2901 Wabash Ave  
Addendum #2  
January 29, 2025

See attached ASI 02

**MECHANICAL HVAC PLAN - AREA 'A'**  
**INDIANA DEPARTMENT OF ADMINISTRATION - TERRE HAUTE OFFICES**  
FSSA CALL CENTER  
2801 WABASH AVENUE  
TERRE HAUTE, INDIANA 47803

**P102C**

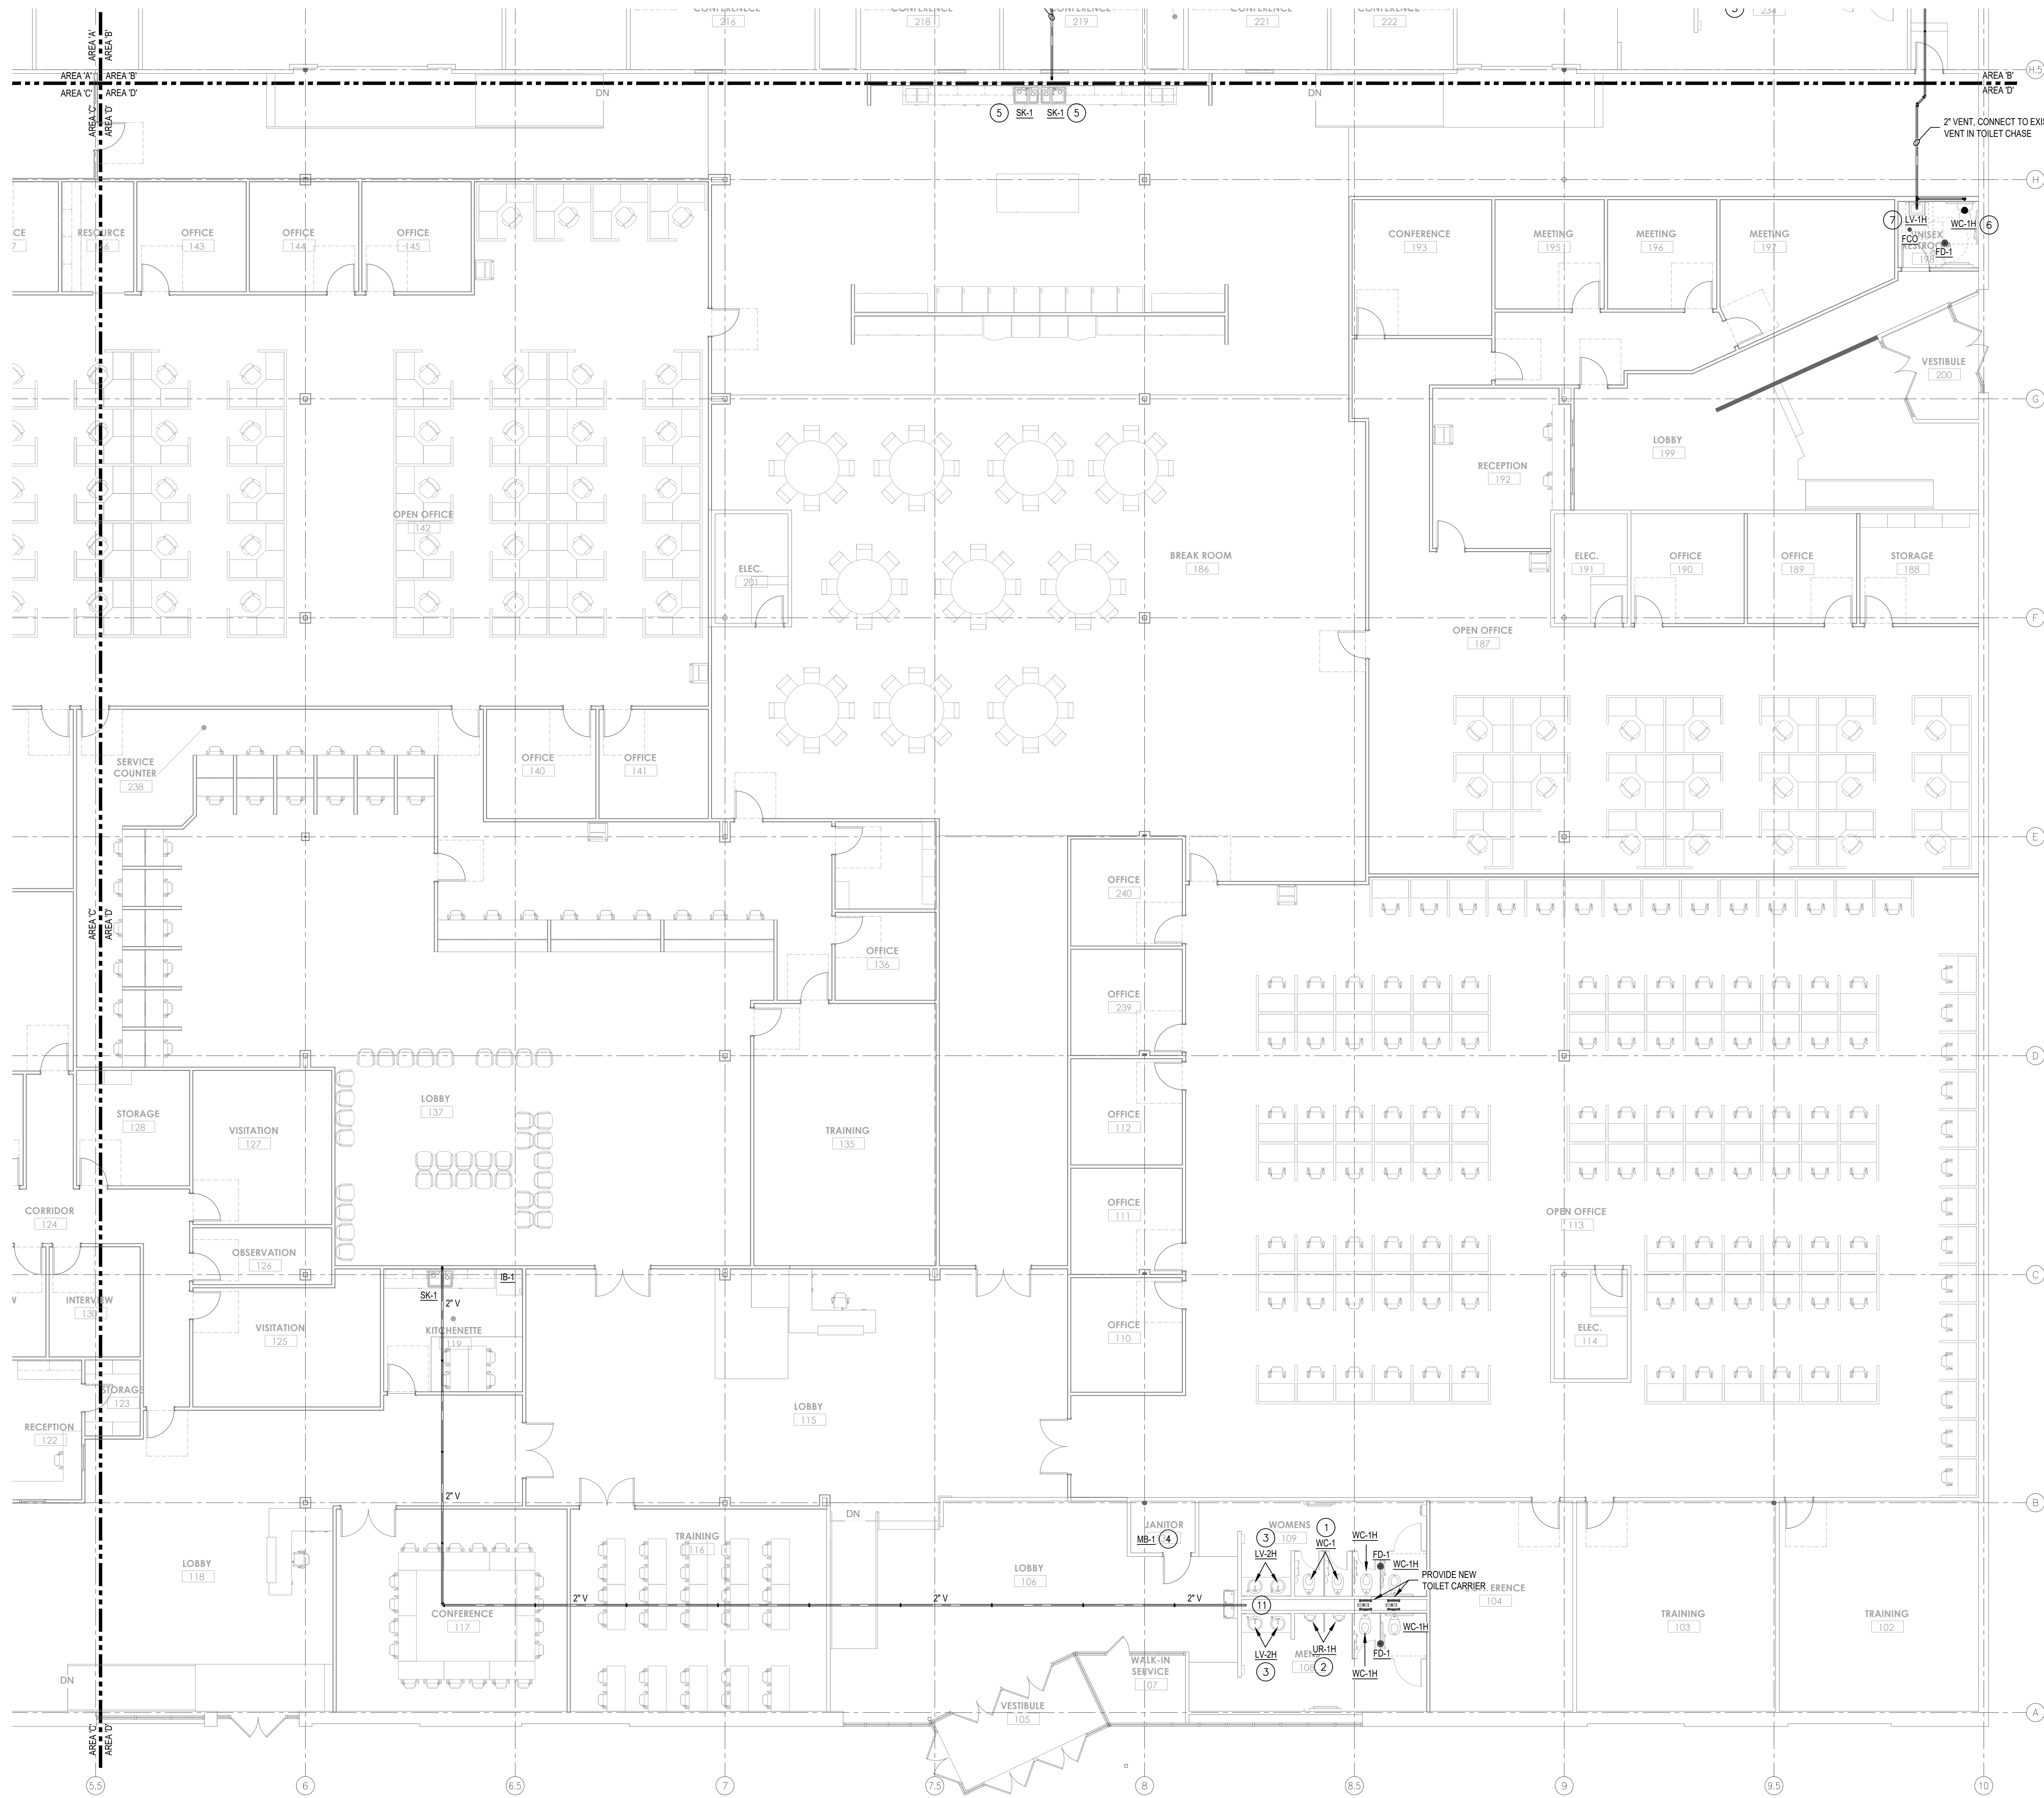
- Added fixtures in Open Office 185
- Added under sink ejector pump manufacturer and model number
- Deleted icemaker boxes in the breakroom

P201D – PLUMBING DOMESTIC WATER PLAN AREA D

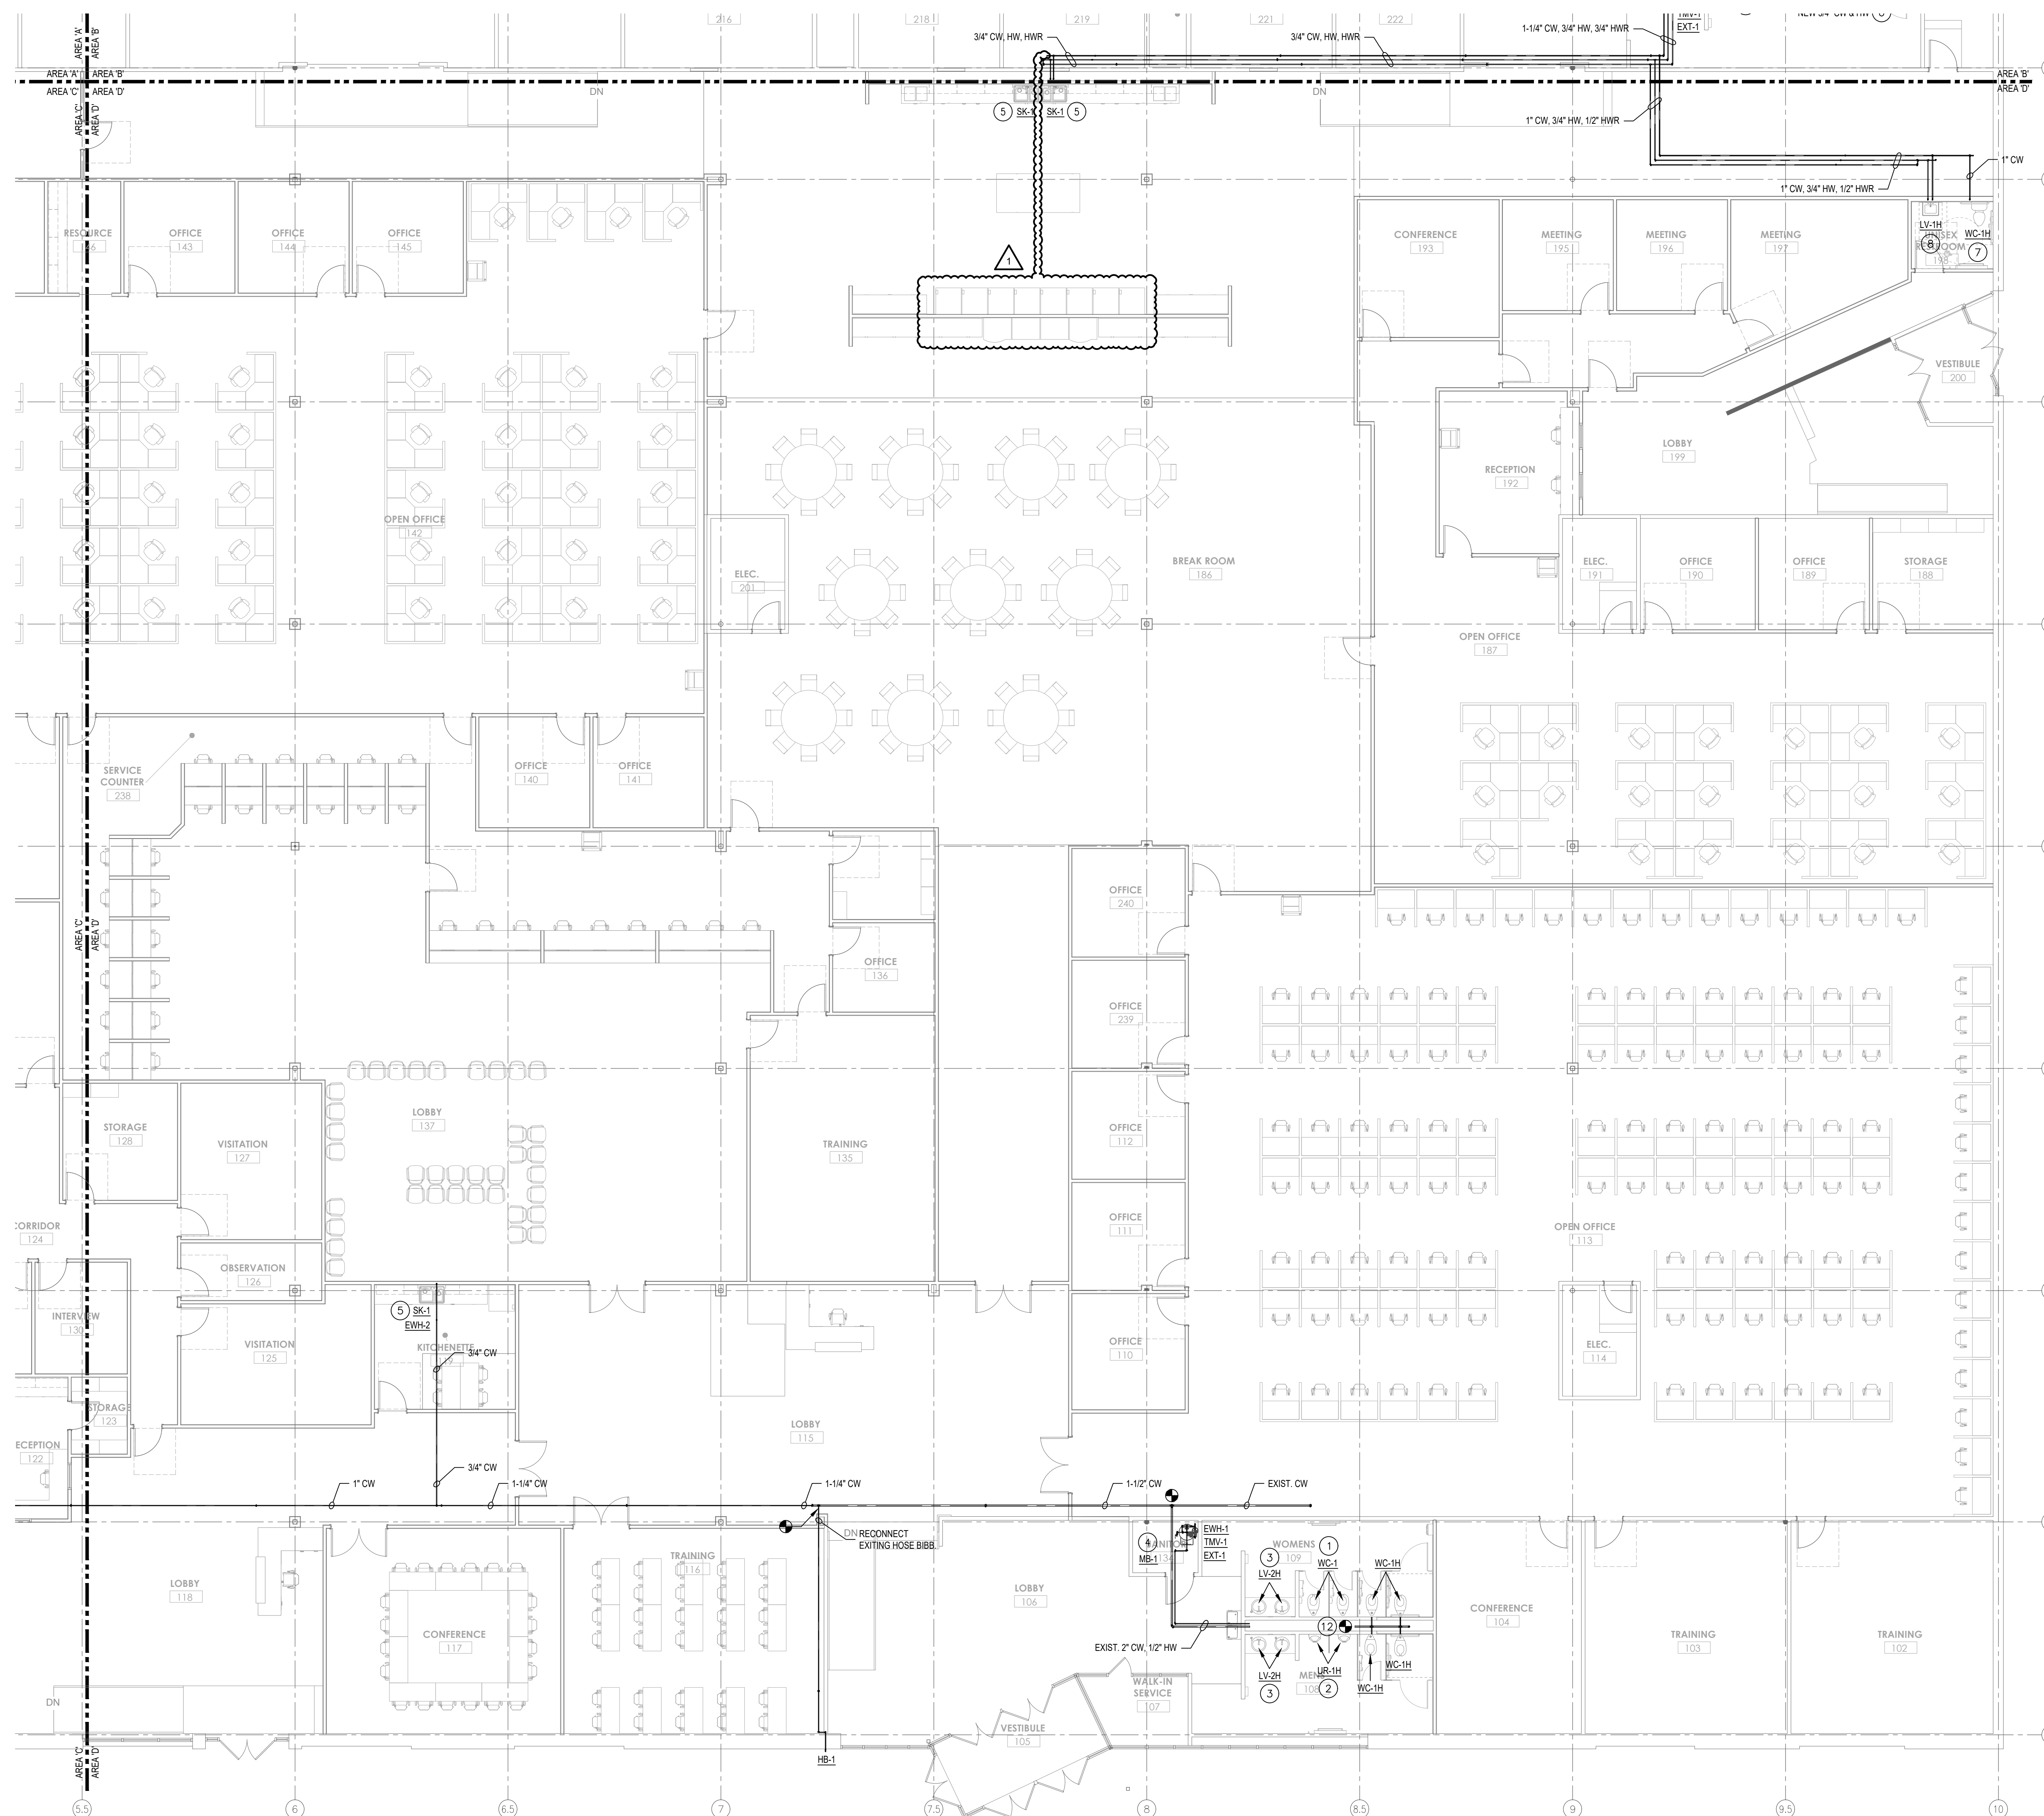
13	P201D shows an EWH-1, TMV-1, and an EXT-1, but there is no size or model called out on the plumbing schedule?			See Plumbing Equipment Schedule on sheet P701 in ASI 2
14	There is a note"12" in the chase on P201D, but the note is not called out in the plan notes, what is this?			Note 12 should read "Extend existing cold water manifold in chase".
16	P201D, WC-1H in room 198 shows being feed by 1/2" copper drop coming off a 1" copper line, this is not enough to feed a wall mount water closet with a flush valve, do you want to use a floor mount pressure assist toilet or up size the line?			See Plumbing Equipment Schedule on sheet P701 in ASI 2. See sheet P201D in ASI 2
17	While visiting the site, I noticed that the existing doors are 8x8 not 8x10 as shown on the door schedule. I wouldn't think that they are going to raise the openings to 10'? Who is removing the existing overhead doors?			Doors to be 8x8. Removal of existing overhead doors to be by Overhead Door Contractor
